Number G.2. (2nd issue)
Section Propeller Shaft

PROPELLER SHAFT JOINTS

Number G.5.
Section Propeller Shafts.

J A G U A R
 S E R V I C E A N D S P A R E S O R G A N I S A T I O N
 S E R V I C E B U L L E T I N N O . 2 3 2

Check 1.

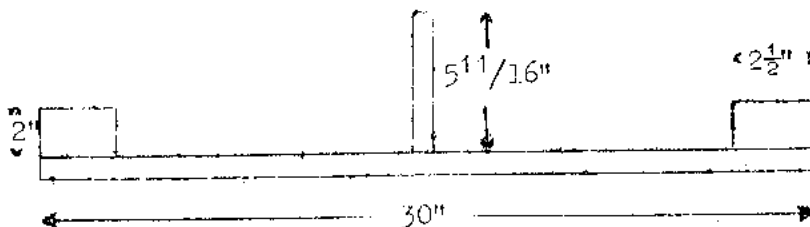
Check the distance from the bottom of the front flange of the front propeller shaft to the bottom faces of the longitudinal chassis side members. This distance should be $3.11/16" \pm 1/16"$ (93.5 mm \pm 1.5 mm). A simple checking jig can be made for checking this distance as shown in the following sketch.

Remedy

If the propeller shaft flange is too LOW suitable packings can be fitted between the rear engine mounting rubbers and the mounting brackets at the top or bottom of the rubbers.

If the propeller shaft is too HIGH suitable packing can be fitted between the rear engine mounting cradle and the body floor.

Check 2.

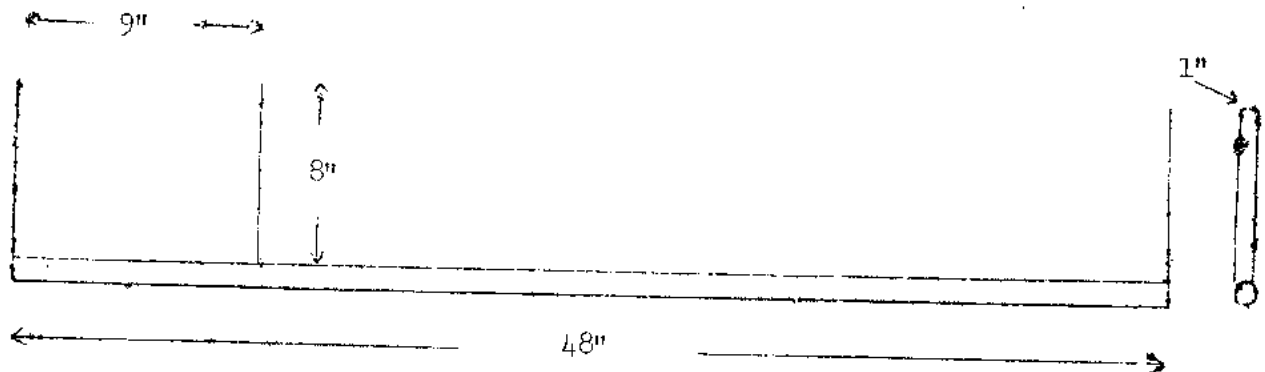
Check that the front and rear propeller shafts are in a straight line in the horizontal plane.

The most convenient way to do this is to make up a simple jig as shown in the following sketch. The jig consists of 3 pieces of flat bar 8" x 1" x 3/16" (20.5 cm x 2.5 cm x 4.75 mm) which are welded exactly in line on to a piece of tube of 1 1/8" (28.5 mm) outer diameter at the distances shown in the sketch. The jig is then held against the front and rear propeller shafts, with the two bars vertical, when any malalignment will be evident.

Remedy.

Alignment of the propeller shafts is carried out at the centre bearing bracket by elongating the two holes through which the setscrews pass to secure the bracket to the body floor. The position of the centre bearing bracket can then be adjusted to allow the propeller shafts to be aligned.
